Product/Process Change Notification

<Laser marking in Film & Paper production>

Date: 21-June-2019	ID Number (MMDDYY): PCN-190621-KB_Laser_mark																																													
Affected Products

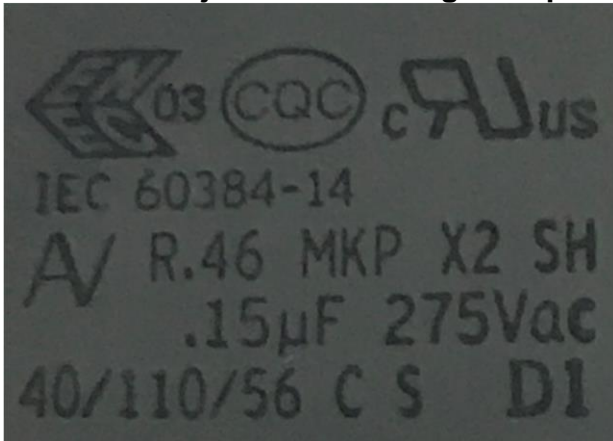
Justification and Benefits	<p>Increase of the production flexibility.</p> <p>Focus on the best practices in upgrading the marking tools and in using the latest state of the technology.</p>
Effective Date and Identification	<p>Starting date for order confirmation: August 1st 2019</p> <p>Intended date for initial deliveries September 1st 2019</p> <p>Without acknowledgement of this notification by July 31st, 2019 KEMET will proceed to implement the change as described herein.</p> <p>No specific identification will be stated on the label because no changes will be operated on the product with the exception of marking art.</p>
To Obtain Samples or General Information Contact	<p>Americas: Mrs. Laura LaBissoniere – Product Manager, LauraLabissoniere@kemet.com</p> <p>APAC: Mr Tony Yu – Product Manager, tonyyu@kemet.com</p> <p>Europe: Mrs. Katerina Bozhinovska – Product Manager, katerinabozhinovskai@kemet.com</p> <p>To obtain some example samples, please add the sentence “Laser Marking” in the request.</p>
